**WATTS BAR NUCLEAR PLANT (WBN) - TECHNICAL SPECIFICATION CHANGE
TS-01-04, DIESEL GENERATOR (DG) RISK INFORMED ALLOWED OUTAGE TIME
(AOT) EXTENSION - REQUEST FOR ADDITIONAL INFORMATION AND
SUPPLEMENT TO AMENDMENT REQUEST**

Enclosure 1
NRC Request for Additional Information
From the Review of TVA's Letter Dated August 7, 2001
Technical Specification Change TS-01-04
Diesel Generator (DG) Risk Informed Allowed Outage Time (AOT) Extension

Enclosure 2
Response to NRC's November 28, 2001,
Request for Additional Information and
Supplemental Response to TVA's Letter Dated August 7, 2001

**Spectrum of Application Effectively
Supported by the PSA**

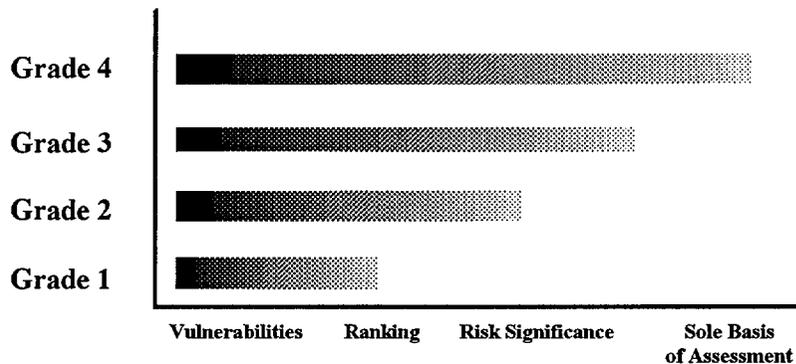
It should be noted that each of the PSA elements listed above were graded by the review team using the following scale. The assigned grades are reflected in the above table and indicate that the WBN PSA is basically adequate for risk informed applications once the specific review observations are addressed. The information provided in this enclosure discusses the relevant observations and TVA's initial disposition of the observations:
